## EXHIBIT 1

Application/Control Number: 10/591,298  
Art Unit: 4125

### DETAILED ACTION

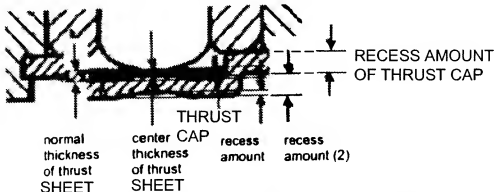
Line 26-29, page 3 recites "... a thrust sheet which is thinner than a recess amount of the thrust cap is provided between the thrust cap and the shaft". However, Fig. 1 shows the thickness of thrust sheet (even if compared to the thickness at center) is thicker than recess amount (see sketch below). If the 'recess amount' indicates 'recess amount (2)' as shown in sketch below, the thrust sheet can be thinner than the recess amount.

The thickness of thrust sheet mentioned in the same sentence above is not uniform according to Fig. 1. Therefore, it is not clear which portion of the sheet is referred for comparison. The examiner understands the thickness at the center portion is of interest. Appropriate correction is required.
